PREDETERMINATION SETTLEMENT AGREEMENT

CP# 09-19-73967
HUD# 07-19-2742-8

According to the Certificate of Occupancy, Union on Lincoln Way (“Union”) consists of one mixed-use building with retail spaces, hotel units, and 157 residential units housed on six stories. However, according to the construction plans there are 158 residential units because Respondents stated they built an additional unit – Unit H118 – which is only rented on month-to-month basis.

Respondents submitted construction plans for Union. The plans included instructions and diagrams for the installation of wall-mounted mailboxes as shown in the captioned figures (*see* Figures 1, 2, 3, and 4) below:³

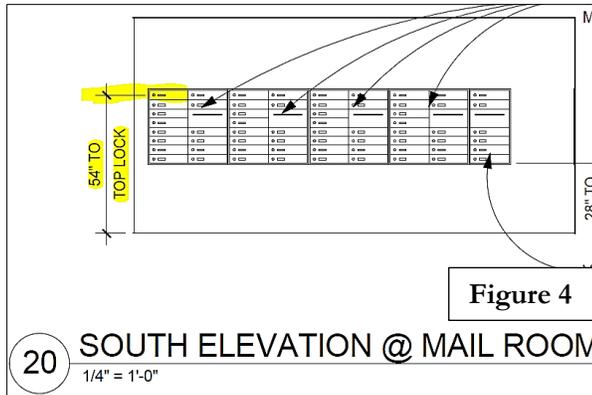
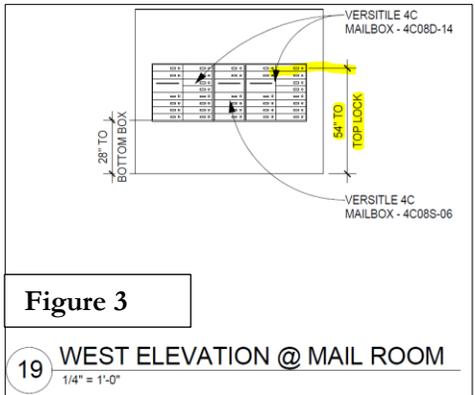
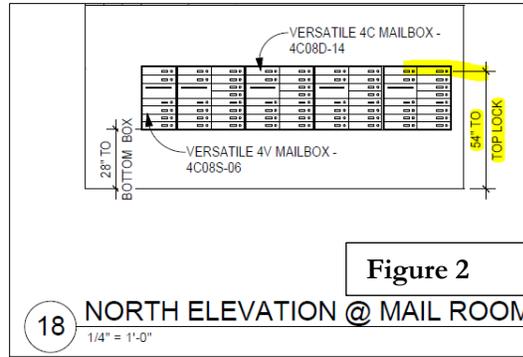
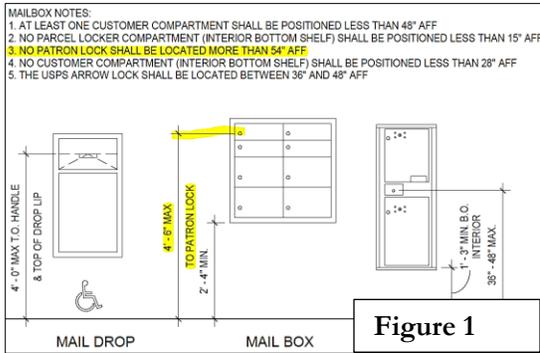
There is sufficient clearance in front of all wall-mounted mailbox units to allow for a parallel approach by persons using a mobility-assistive device such as a wheelchair. The heights to the midline of the keyholes at the top row of mailboxes was measured at 54 1/2". ICRC Investigators took the following photographs (*see* Photos 1 and 2) to document the measured height:

As seen above, the top row of mailboxes exceeds the 54"-maximum allowed for a parallel approach by ANSI 1986.

If the mailboxes had been installed as they were designed, they would have been compliant with the 54"-maximum height allowed. However, as installed, the top row of mailboxes exceeds this maximum height, which renders these mailboxes inaccessible.

(b) Respondents agree they will install two additional 14-compartment wall-mounted mailbox units that the west wall in the mailroom, such that the height to the midline of the keyhole at the top row of mailbox compartments in the new wall-mounted mailbox units does not exceed the 54”-maximum height allowed by ANSI 1986.

Respondents submitted construction plans for Union. The plans included instructions and diagrams for the installation of wall-mounted mailboxes as shown in the captioned figures (*see* Figure 5) below:⁴

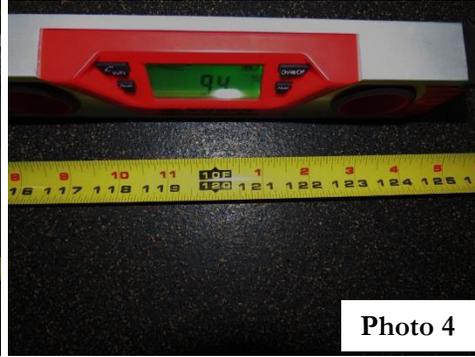
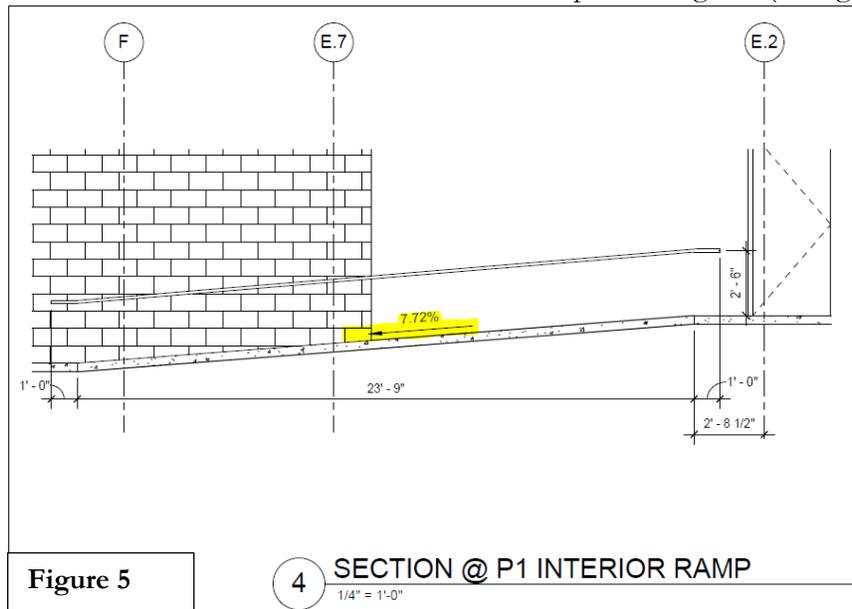
The following table lists only running-slope measurements exceeding the 8.33%-maximum running-slope allowed, and includes the location of the slope measurement. ICRC Investigators took photographs to document the measurement of the slopes, which are shown after the following table.

DISTANCE BETWEEN EDGE OF THE LANDING AT THE TOP OF THE RAMP AND LOCATION OF MEASUREMENT	PHOTOGRAPH	RUNNING SLOPE
12"	Photo 3	8.8%
120"	Photo 4	9.4%
138"	Photo 5	9.4%
174"	Photo 6	8.6%

The above-reported running slopes at the inspected sections of the interior ramps exceed the 8.33%-maximum running slope established by the Manual and ANSI 1986 for ramps with handrails.

If the ramp had been built as it was designed, the running slopes along the entire length of the ramp would have been compliant with the 8.33%-maximum running slope allowed. However, as built, the running slope along the only route to the fitness center without steps exceeds the maximum running slope allowed, which renders this path inaccessible to persons who utilize wheelchairs for mobility.

(b) Respondents agree to rebuild the interior ramp to the fitness center such that those interior ramp sections, once corrected, and the remainder of the ramp, will have a running-slope value of no more than 8.33% and a cross-slope value of no more than 2%, as required by ANSI 1986 and 2010 ADAAG.

The construction plans submitted by Respondents included instructions and diagrams for the installation of wall-mounted dispensers as shown in the following captioned figure (*see* Figure 6).⁵

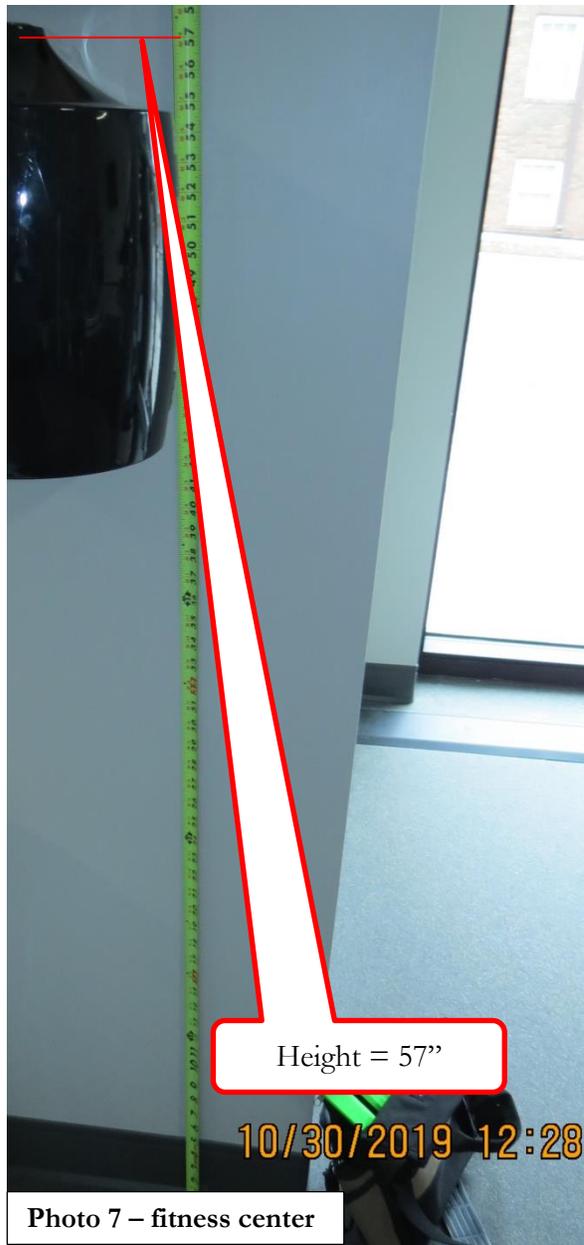
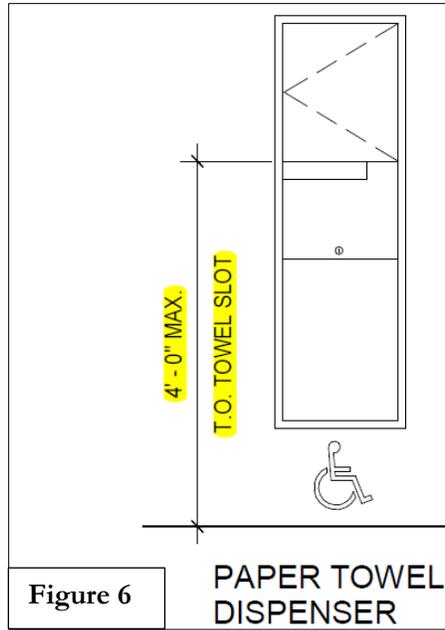
3) ICRC Investigators measured the height of the paper towel dispenser located in the lobby; and four towelette-wipe dispensers at the fitness center. There is enough clear floor space in front of these dispensers for residents using wheelchairs to make a parallel approach. The height of all dispensers in the fitness center was measured at 57" and at 64" for the paper-towel dispenser in the lobby. These heights are greater than the 54"-maximum height allowed in ANSI 1986. The following are sample photographs taken by ICRC Investigators to document the measured heights:

According to the diagram and instructions shown above, the paper-towel dispenser was designed to be installed no higher than 48” above the floor surface directly below. Although no diagrams or instructions were found in the plans for the towelette-wipe dispensers, it is reasonable to expect them to be installed at the same height as the paper-towel dispenser due to the similarities in both of these fixtures. If these dispensers had been installed as they were designed, they would have been compliant with the 54”-maximum height allowed. However, as installed, these dispensers exceed this maximum height, which renders them inaccessible to persons who use a wheelchair for mobility.

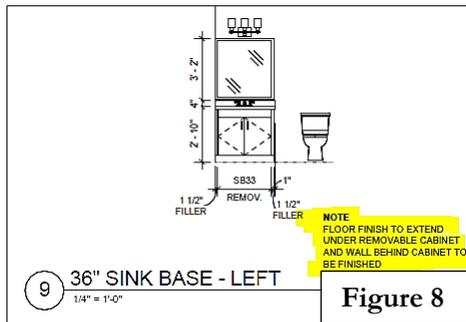
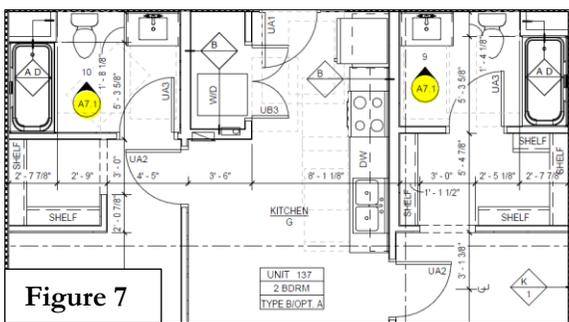
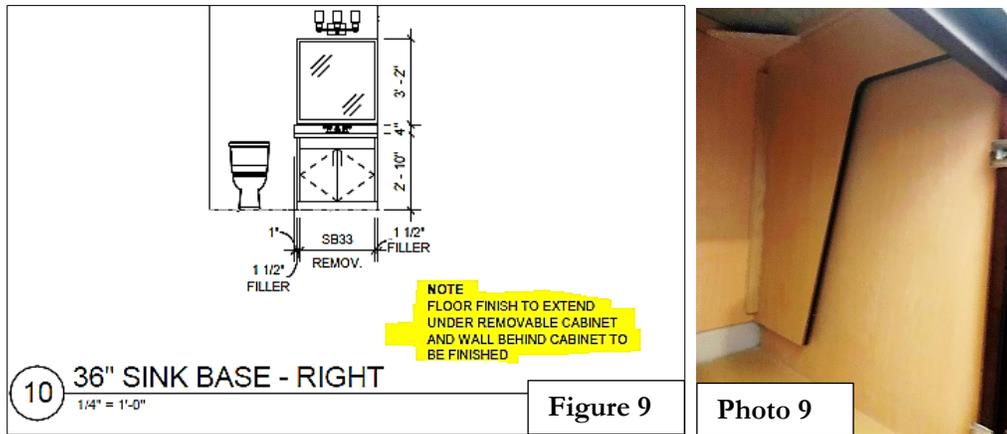
4) In Unit 137, the midline of the sink was measured to be 18 ¼” from the adjoining wall, which is less than both the 24”-minimum requirement if the base cabinets are not removable, but is more than the 15”-minimum requirement if the base cabinets are removable. Respondents submitted plans and photographs in support of their claim that the base cabinets under the bathroom sinks at Unit 137 are removable (*see* Figures 7, 8, and 9; and Photo 9).

The base cabinets in the bathroom in Unit 137 appeared to be removable to ICRC Investigators because they observed the presence of side brackets underneath the sink to support the sink in the event the base cabinets are removed. Also, ICRC Investigators verified the dimensions of the knee space area under the sink are compliant with the dimensional requirements from the Manual previously cited in this report.

So, the bathroom sinks in Unit 137 were found to be compliant with the clear floor space requirements for a forward approach because the midline of the sink was further away from the adjacent wall than the 15"-minimum required.
